RSN: 1881854 | PERMIT#: 25-2513934-CM

City of Aurora Building Division
Reviewed for Code Compliance
Approved as Noted: Robert Lowman
Date: May 06, 2025
2021 INTERNATIONAL CODES & 2023 NEC

2/4/2025 4:17:20 PM P06-06 WATER RISER DIAGRAM SEGMENT F/H

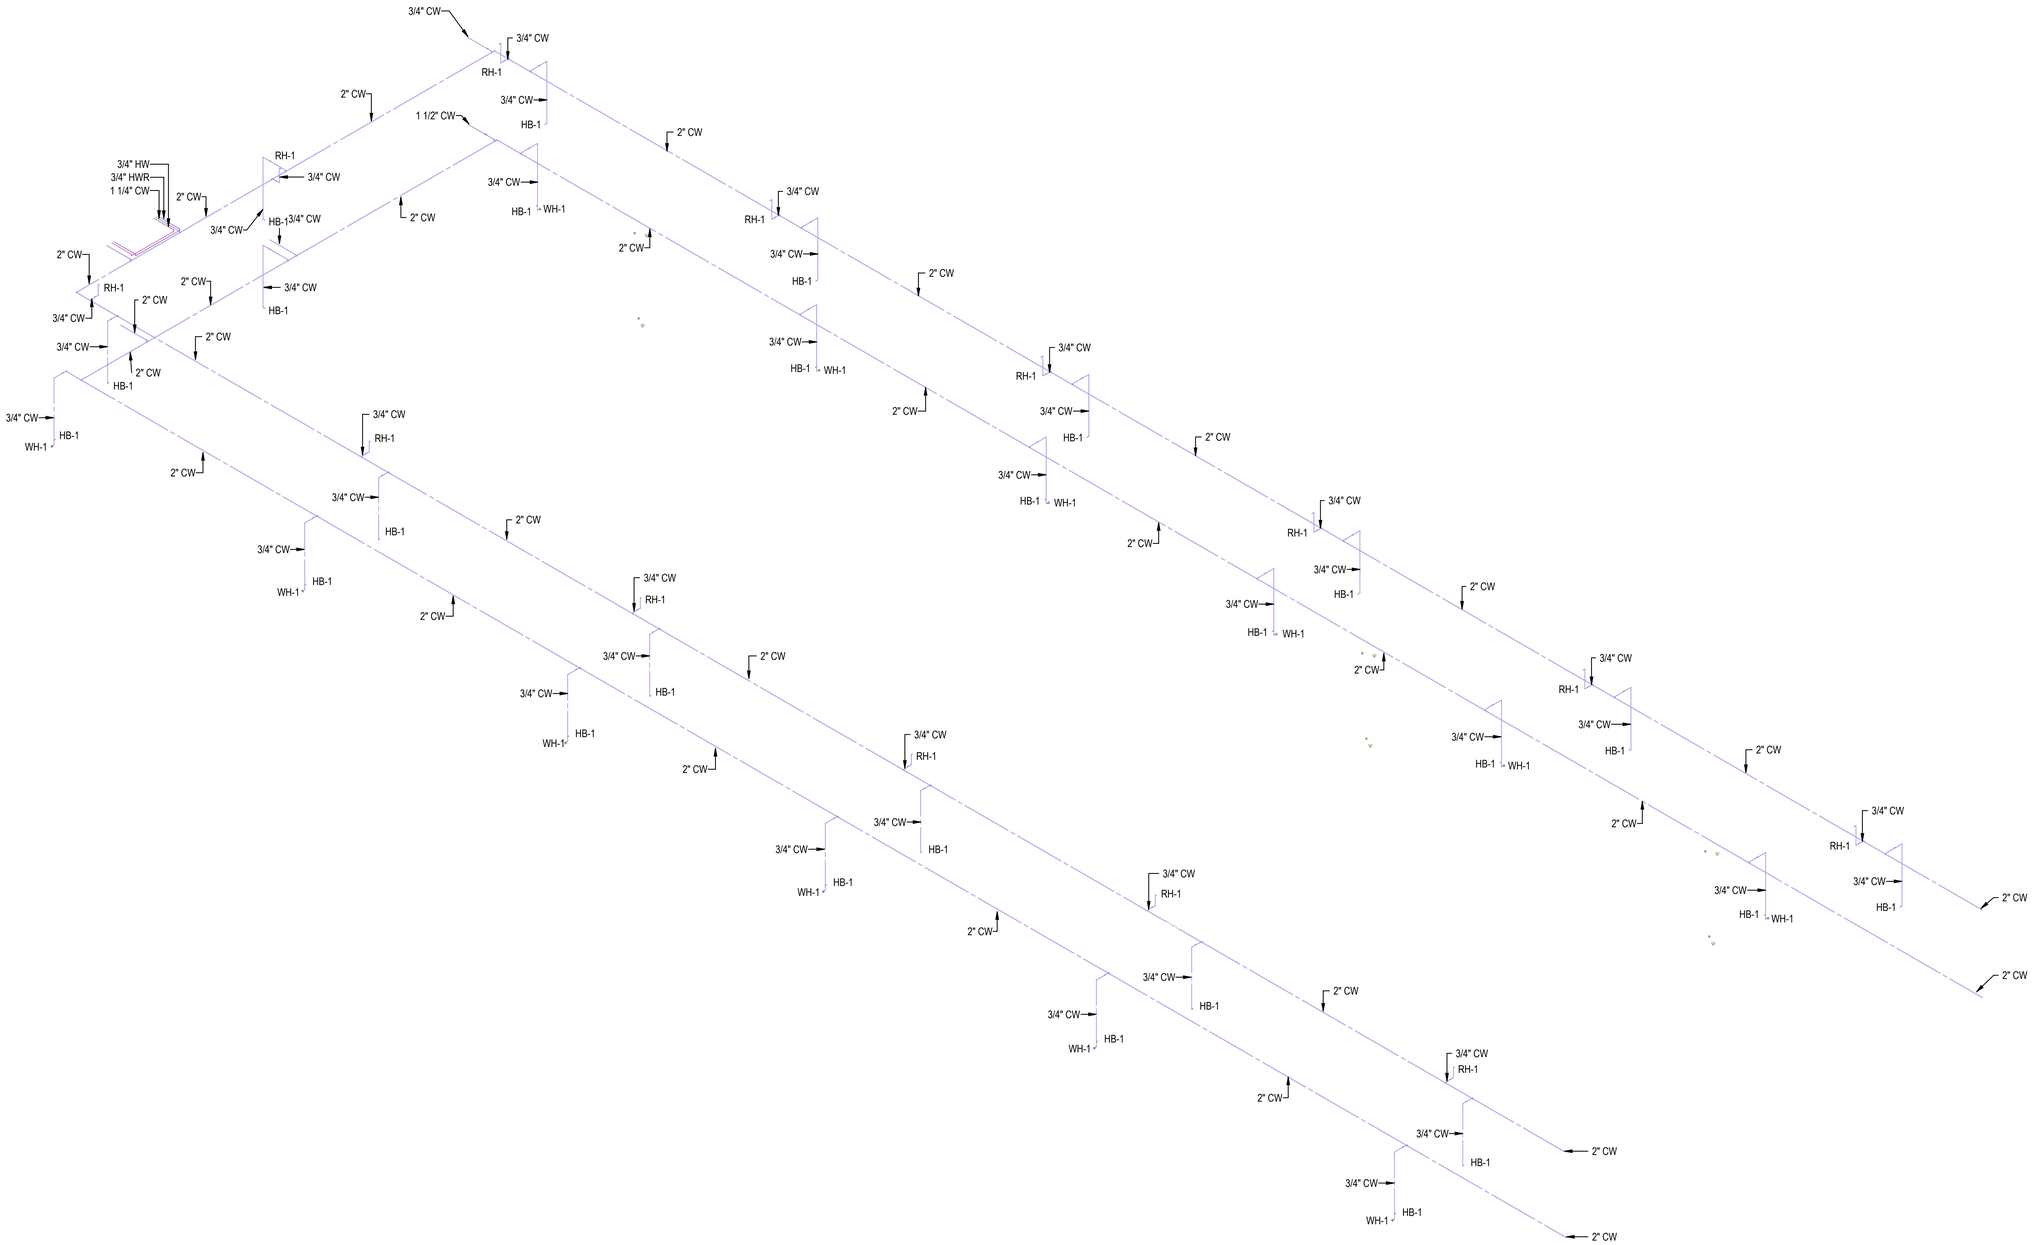
PROVIDE PIPE INSULATION PER 2021 IECC TABLE C403.12.3

2/5/2025 9:43:15 AM E00-01 SYMBOLS, ABBREVIATIONS AND GENERAL NOTES

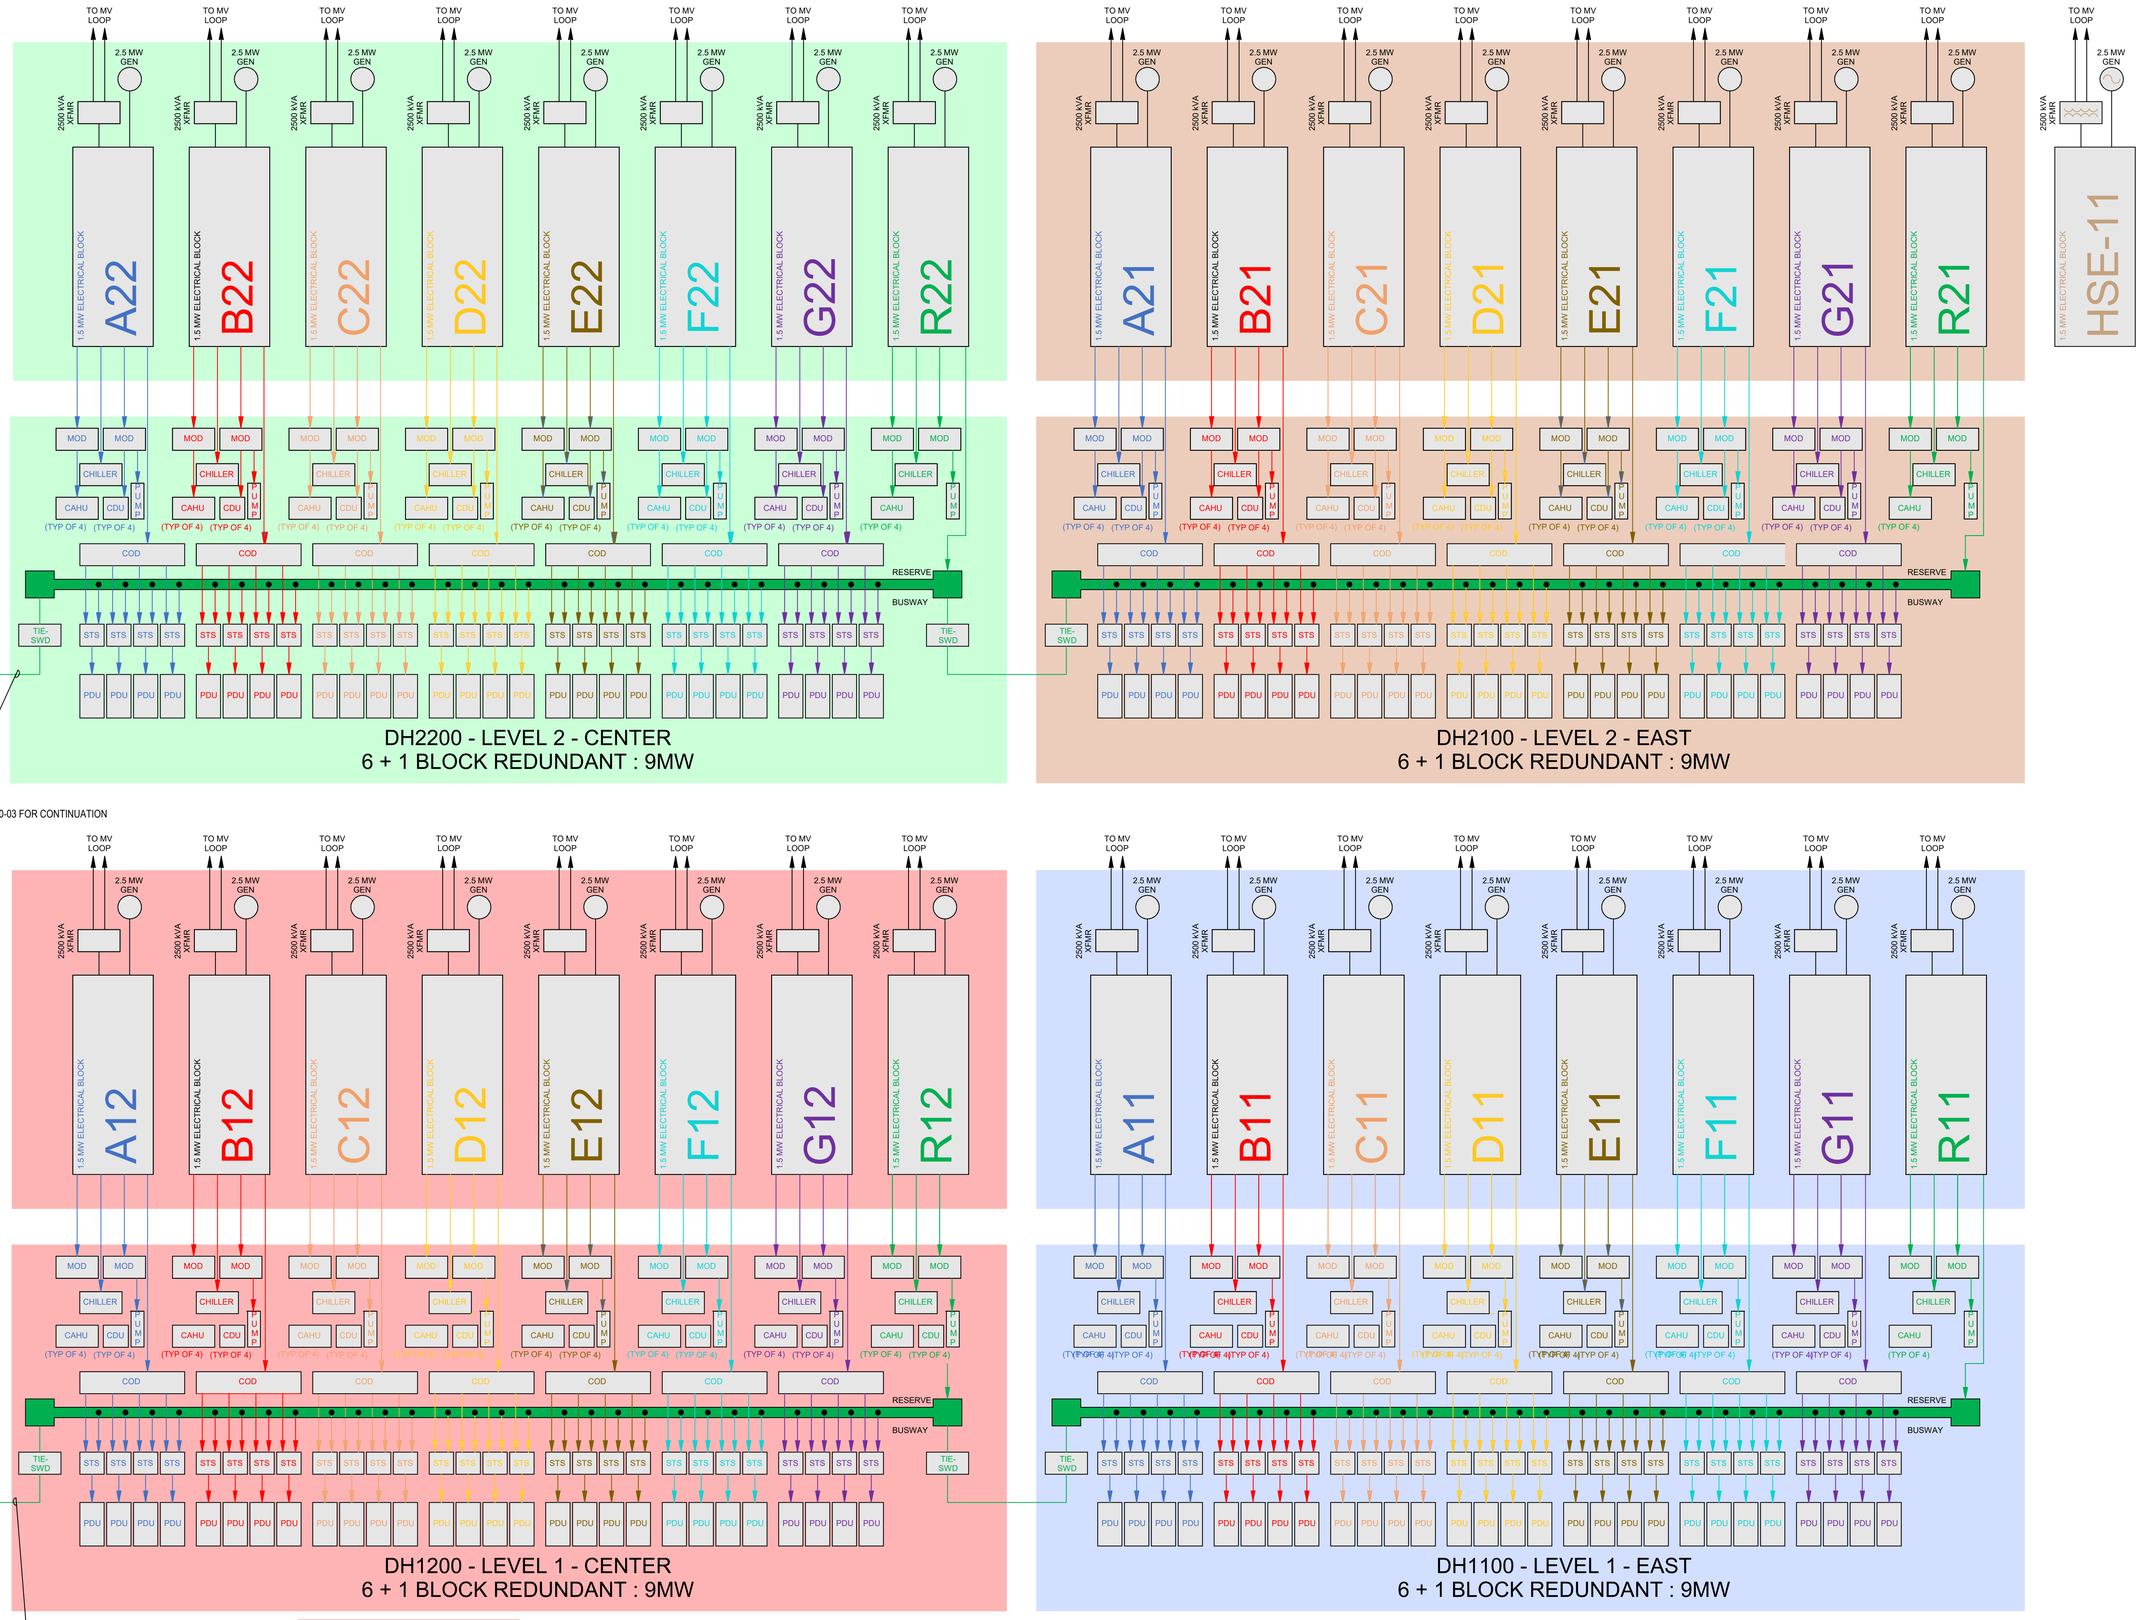
This sheet of drawings has not been reviewed for code compliance.

2 LEVEL 1 LIGHTING ENTRANCE PLAN
SCALE: 3/64" = 1'-0"

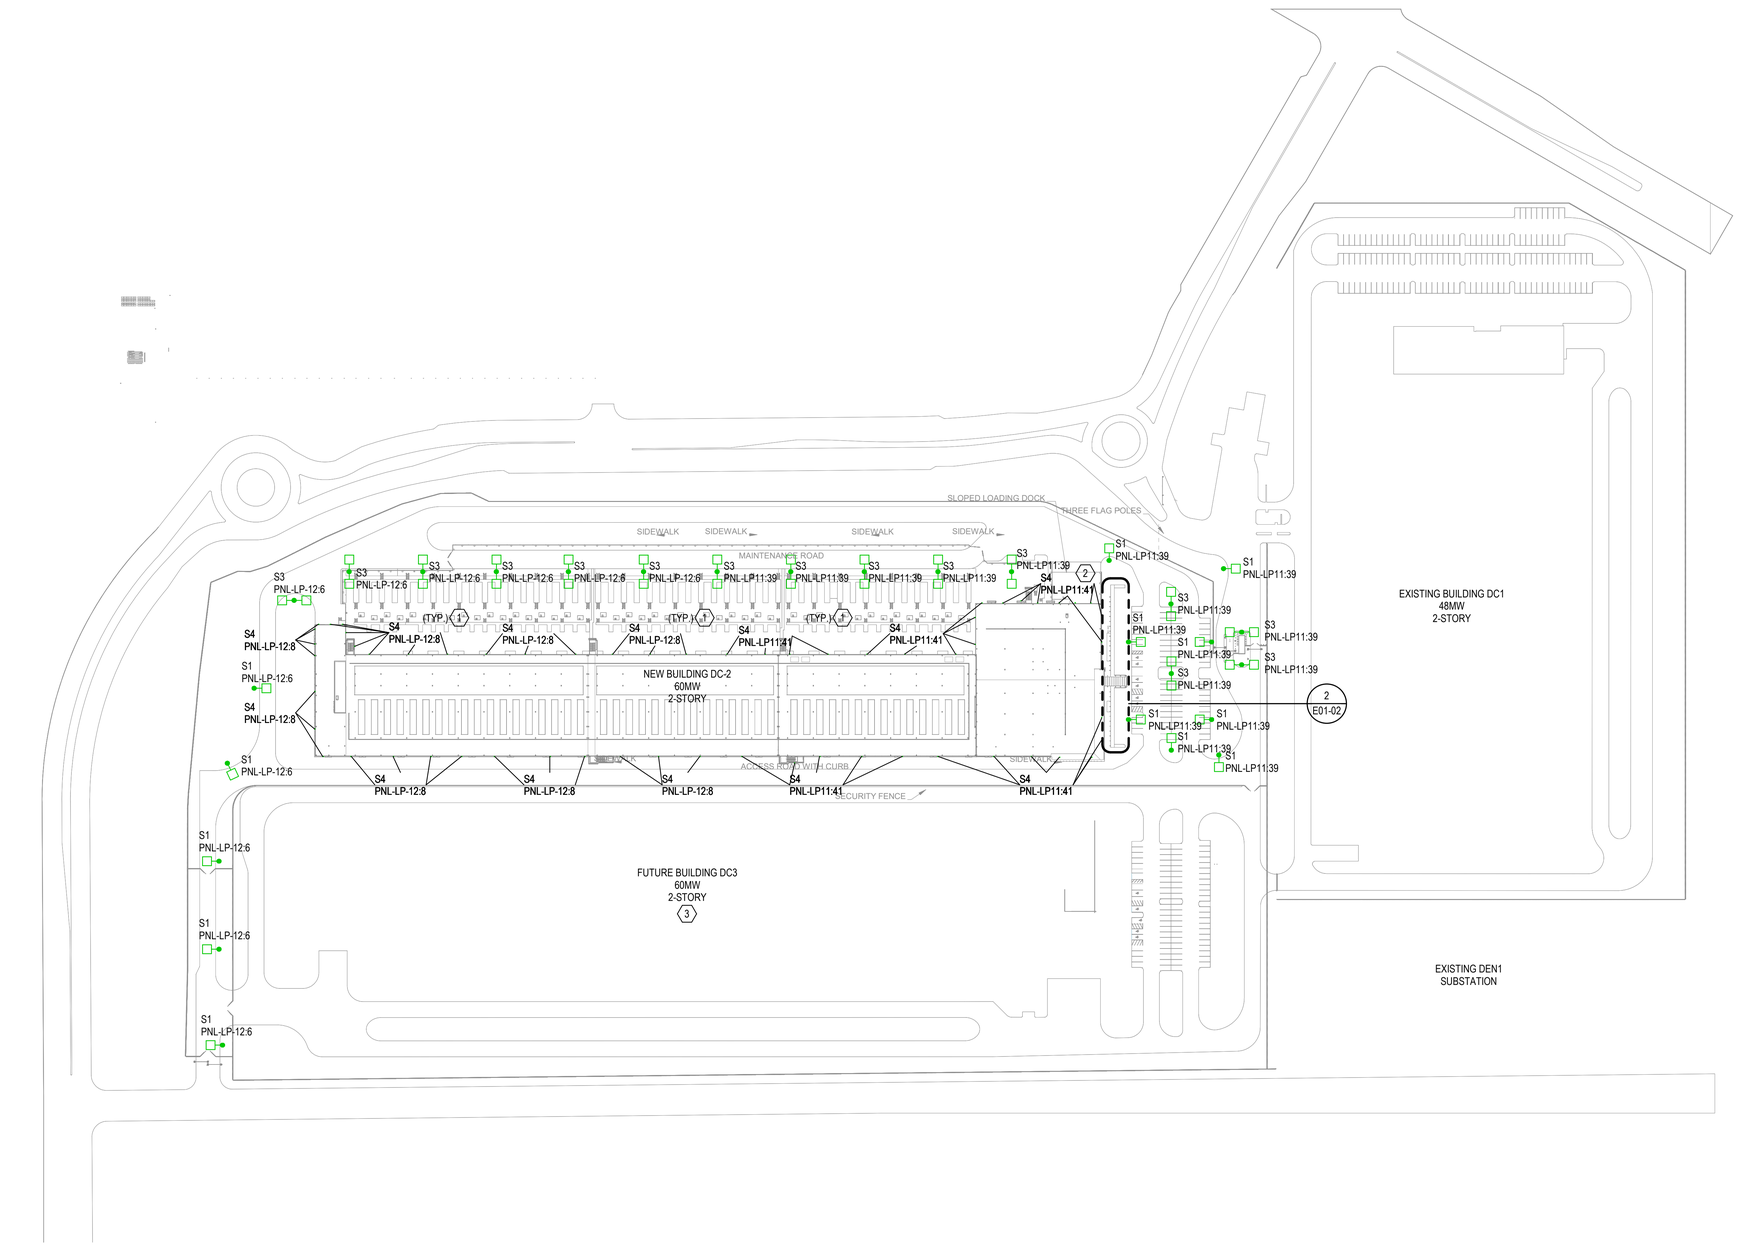
Wet and Damp Locations. Luminaires installed In wet or damp locations shall be installed such That water cannot enter or accumulate in Wiring compartments, lampholders, or other Electrical parts. All luminaires installed in wet Locations shall be marked, "Suitable for Wet Locations". All luminaires installed in damp Locations shall be marked, "Suitable for Wet Locations or "Suitable for Damp Locations" Per 2023 NEC 410.10(A).

1 LEVEL 1 GROUNDING PLAN - B
SCALE: 1/8" = 1'-0"

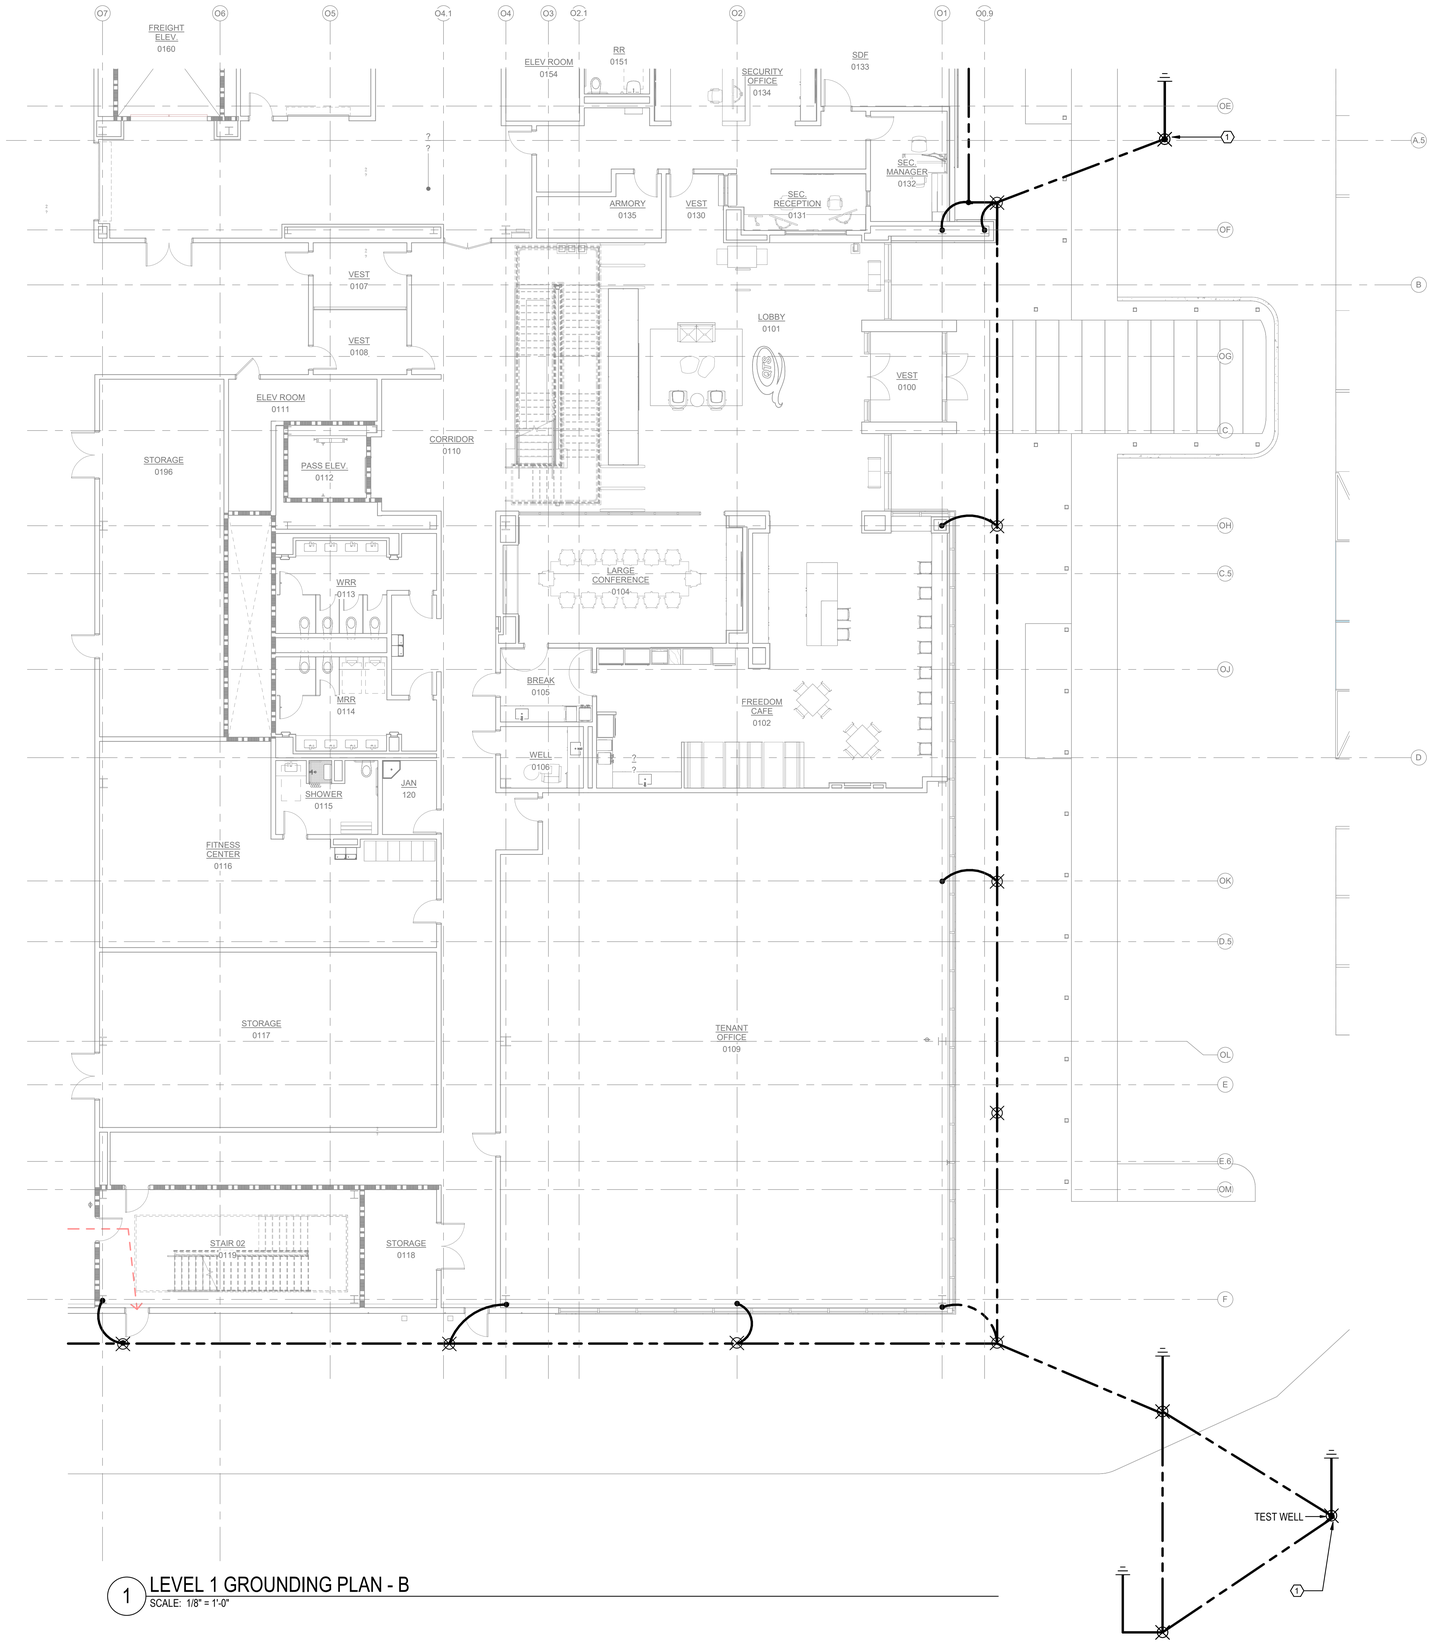
A. ~~SEE DRAWING E0.01 FOR LEGENDS, NOTES AND ABBREVIATIONS.~~
B. SEE DRAWING E05 SERIES FOR GROUNDING DETAILS AND DRAWING E03-24 FOR GROUNDING RISER DIAGRAM.
C. REFER TO SPECIFICATION 25 05 26 FOR ADDITIONAL GROUNDING REQUIREMENTS.
D. COORDINATE CLOSELY WITH LOCAL AUTHORITY HAVING JURISDICTION AND APPROPRIATE CONTRACTOR(S) TO CONFIRM ALL FINAL INTERCONNECTION LOCATIONS AND REQUIREMENTS.
E. WHERE EQUIPMENT IS CALLED OUT AS HAVING TWO GROUND CONNECTIONS, EACH PIGTAIL SHALL CONNECT BACK TO A SEPARATE GROUND GRID LATERAL.
F. ALL UNDERGROUND CONNECTIONS SHALL BE EXOTHERMIC CONNECTION TYPE.
